PROJECT TITLE  
**PROPOSED MARRIOTT EXPANSION (PHASE II)**

## 10 N. OCEAN BLVD., DELRAY BCH, FL.

## PROPOSED SITE PLAN FLOOR PLAN

**SITE PLAN APPROVAL**

A1.01

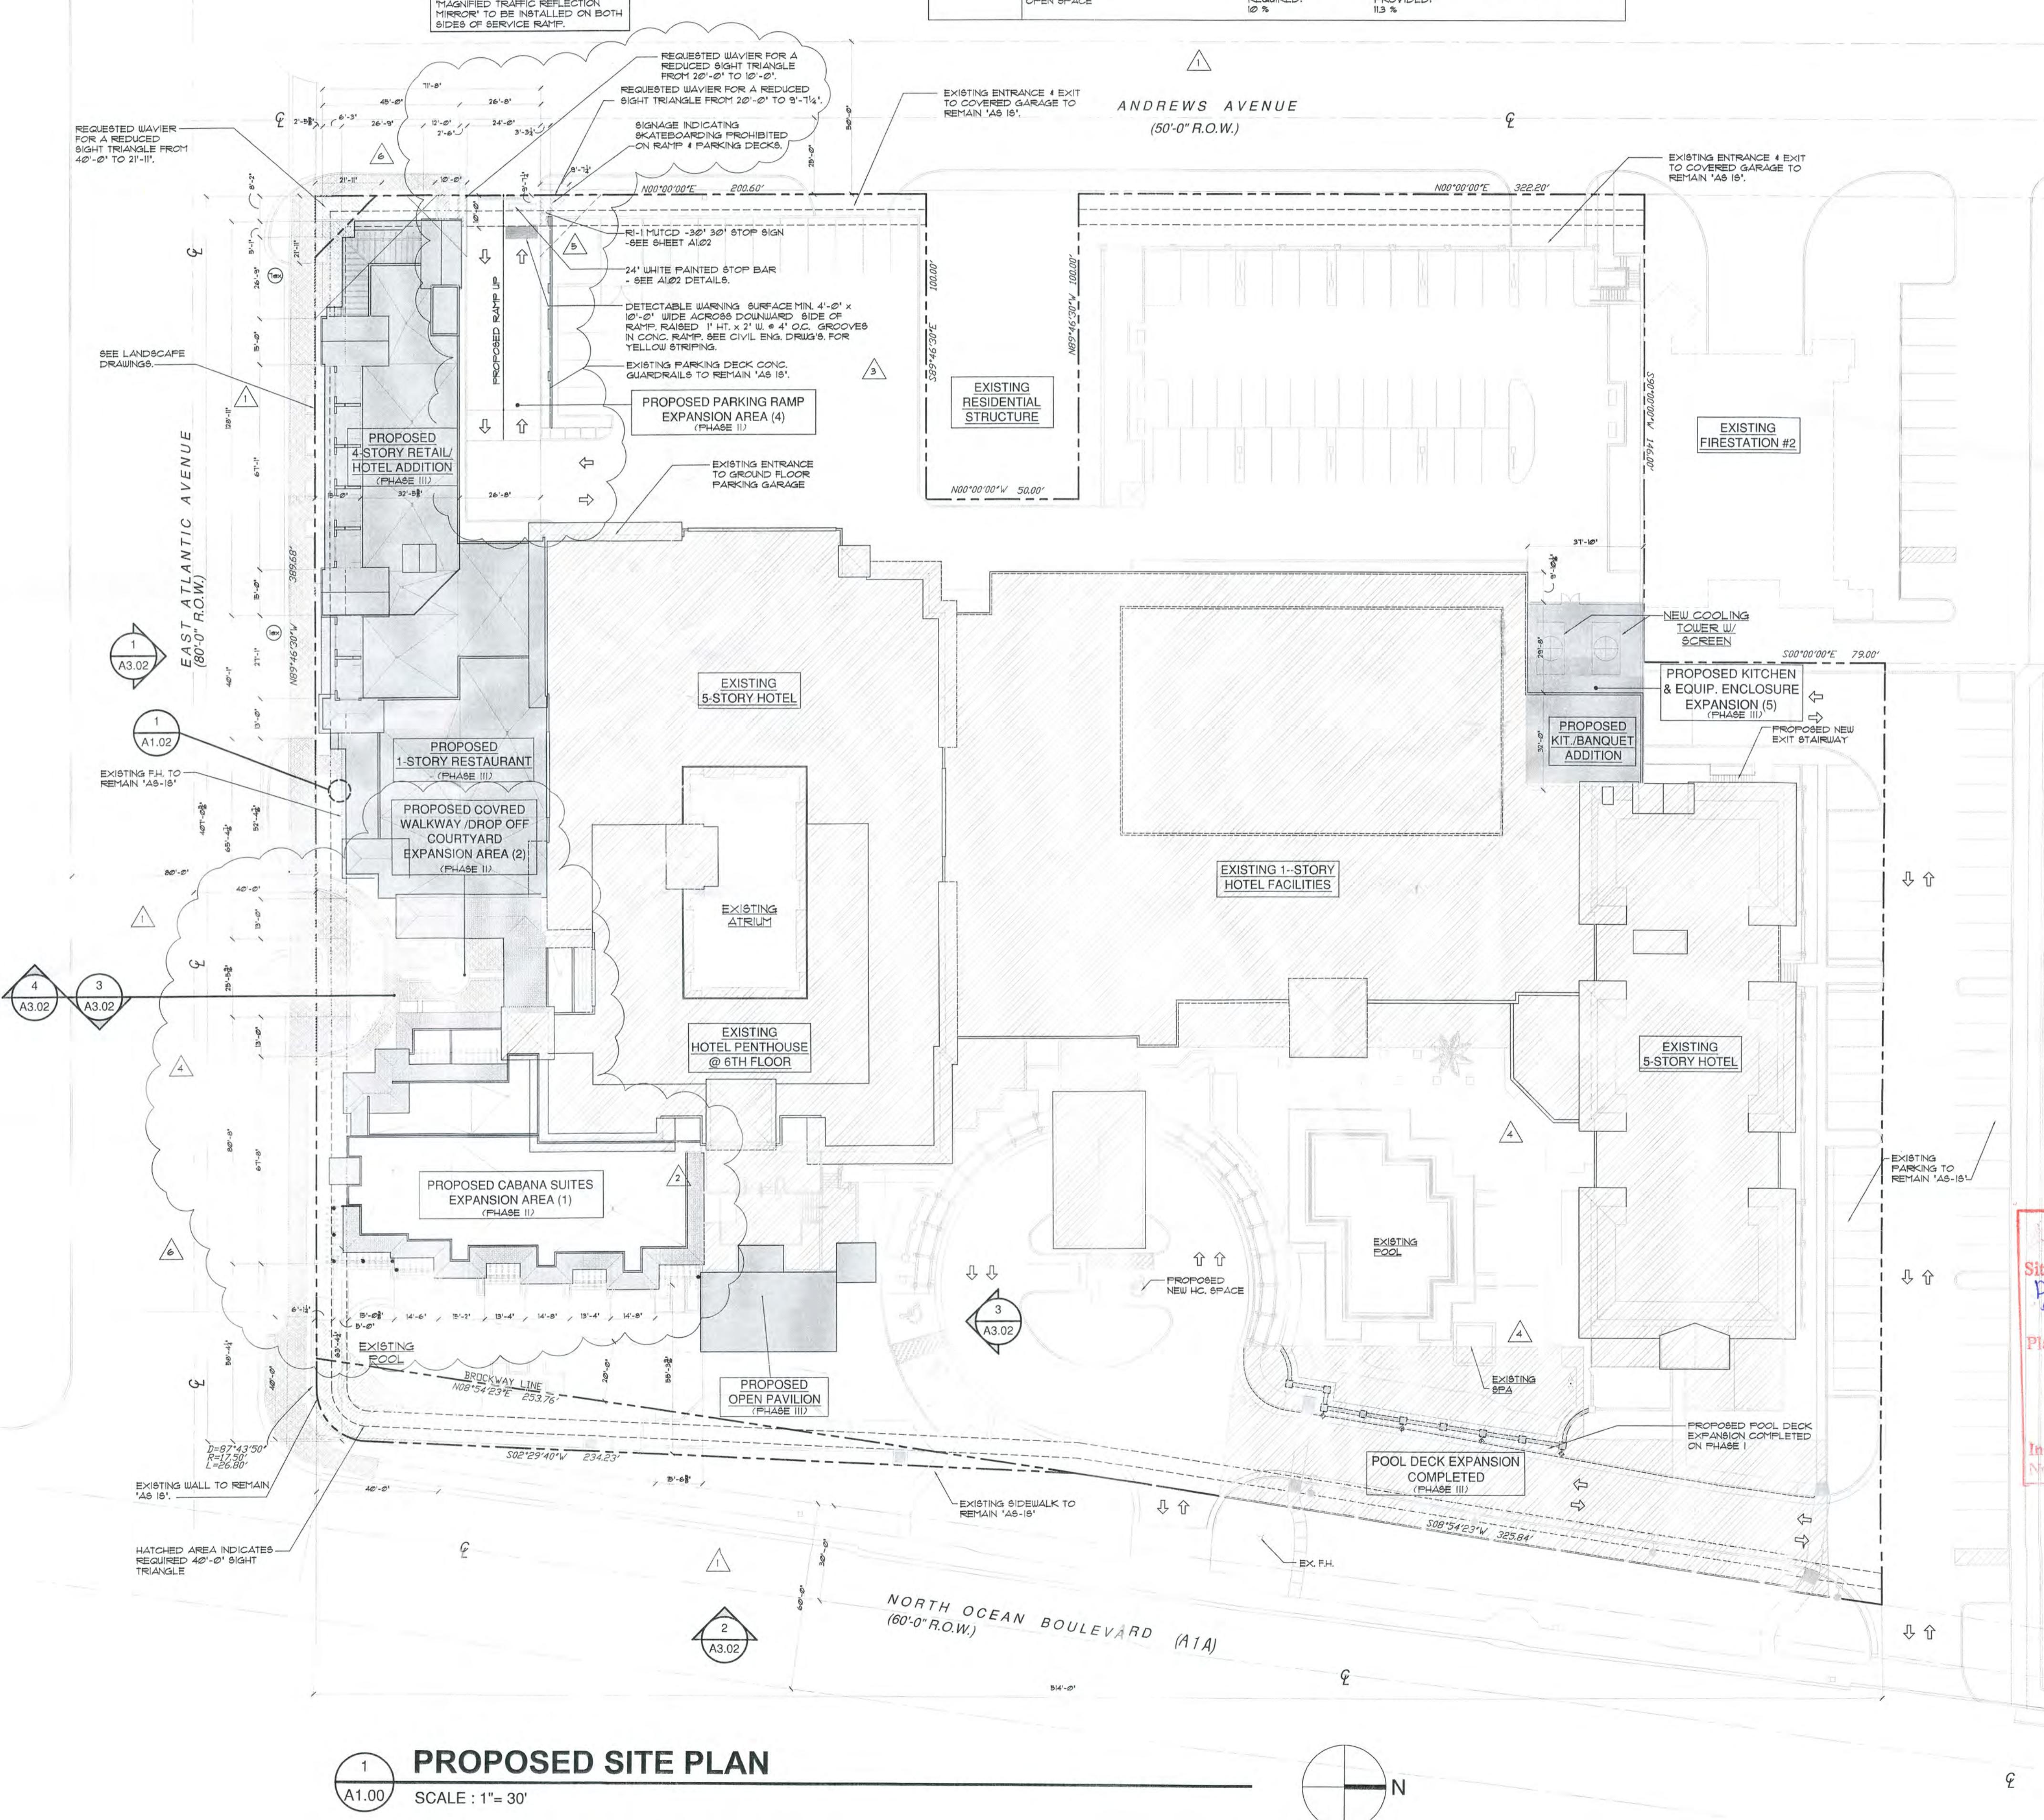
Define these (3) phases and mitigate undeveloped and exterior Cabana suites by reducing rooms from 9 to 8.
